Explanation of Request: Construction of a new manufacturing facility for Sintavia.

**RE: SITE PLAN REVIEW – N.E. Corner of SW 25th Avenue & North of SW 39th Street
FILE NUMBER 17-DPV-33**

Please find below the Site Plan Review case review comments and our written responses for the referenced project.

PROPOSED LANDSCAPE PLAN
1" = 20'-0"

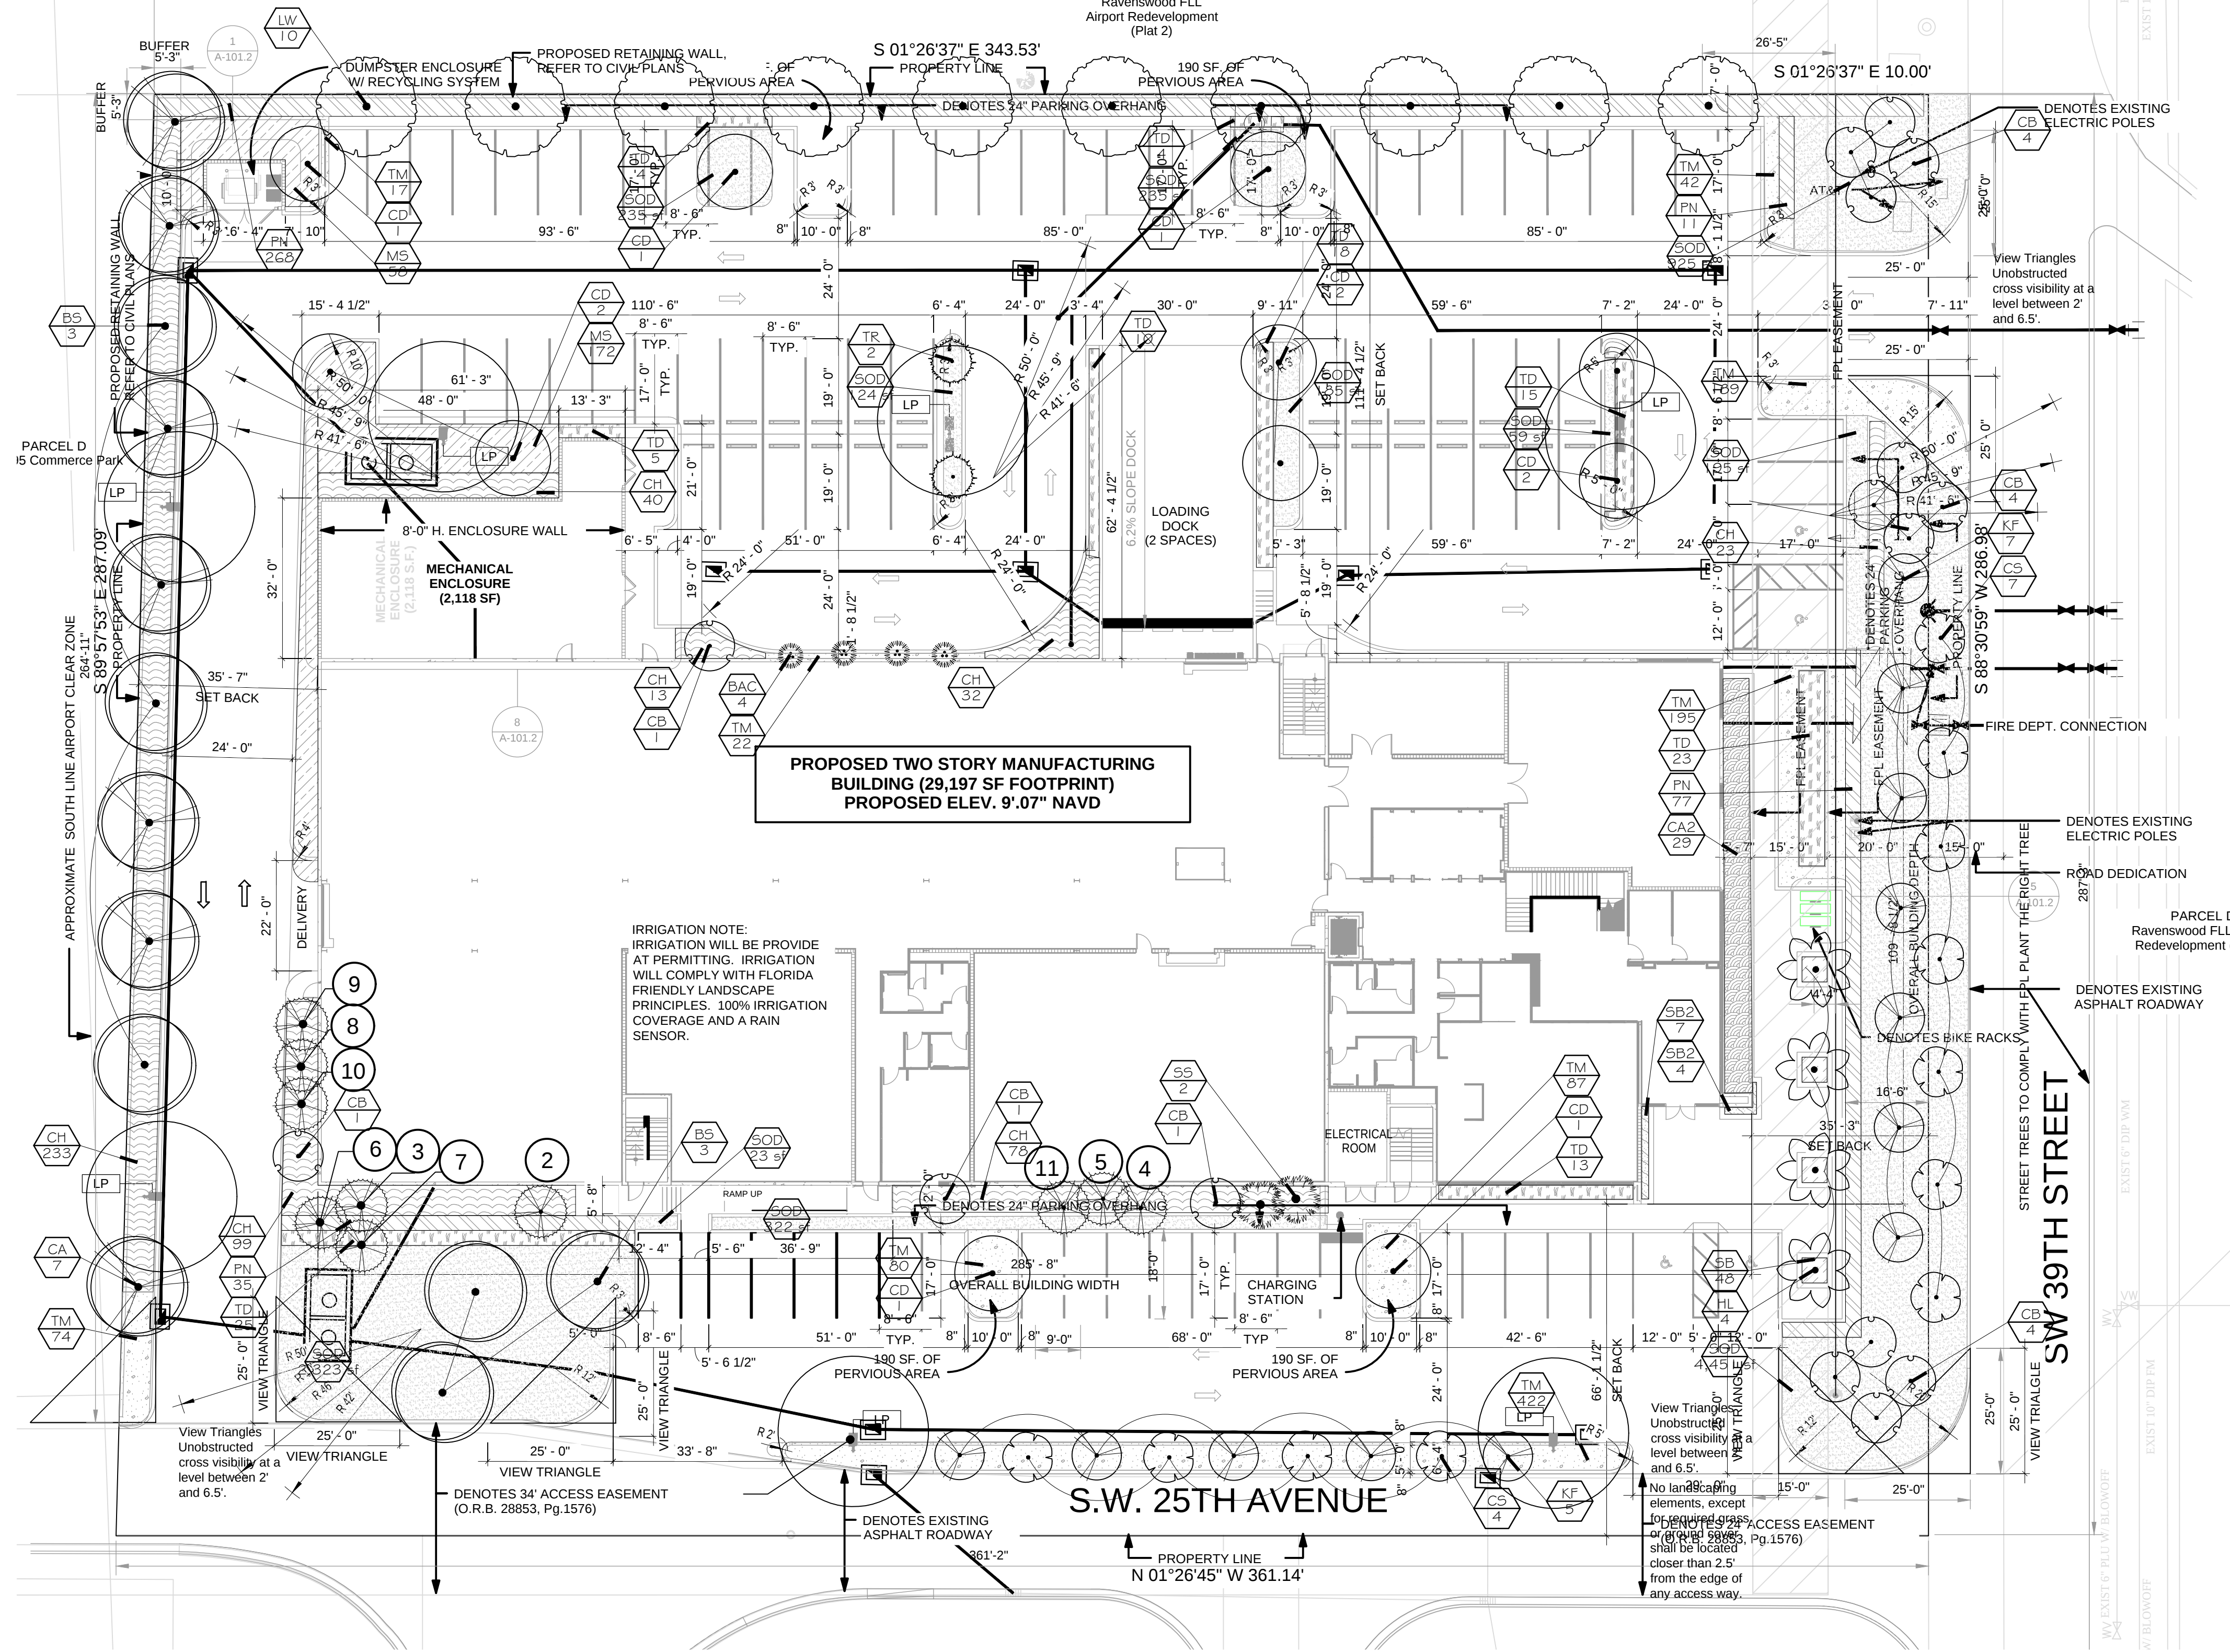
1. Landscape Plans should responsibly maximize shade on the site. Several proposed species have more of an upright habit than a spreading habit. Replace with spreading habit species. Some examples of spreading habit species are: Mahogany, Floss Silk Tree, Royal Poinciana, Calophyllum, , Bulnesia, Paradise Tree, Lysiloma

2. Select appropriate species to take advantage of site opportunities and constraints such as existing overhead or underground utilities. Crape Myrtle would be better suited as accent street trees along the south perimeter where there are existing overhead power distribution line

constraints than on the east perimeter where there is opportunity and space for larger, spreading habit tree species. Heat island effect of building and paved impervious areas: Aim to negate it as much as the site will allow.

3. Along SW 39th St., decrease spacing of small, FPL-approved species to 12' on center and diagonally staggered along entire length to fill the mass of exposed open space. Along this perimeter, substitute Ironwood with another FPL-approved species such as Bottlebrush, Queen Crapemyrtle (*speciosa* not *indica*) Silver Buttonwood, Simpson's Stopper or other.

4. Create tree clusters with a minimum of 4 trees (same species or mixed) at the SE and SW corners of the site as accents, outside of clear sight triangles.

5. Thrinax palms in narrow planter at west elevation: Provide wider planting room between curb and concrete walk to accommodate larger statured palm species that are more in scale with the building height and as depicted on the color rendering sketches.

6. Unrestricted by overhead lines, specify large, spreading habit tree species along west perimeter parking lot buffer median island. If no additional width is provided between curbs, specify use of 24" depth physical root barrier continuous along insides of curbs and the use of a suspended pavement product such as stratacell or CU Structural Soil 5' from outside of curb face in all directions.

7. When underground drainage structure location is refined by Civil Engineer to be located at edge of NE building planting island, specify two iconic, large spreading habit trees such as Royal Poinciana, Yellow Poinciana, or Floss Silk Tree.

8. Tighten spacing of relocated Sabal Palms at east (rear) perimeter buffer and densify with large, spreading habit shade trees.
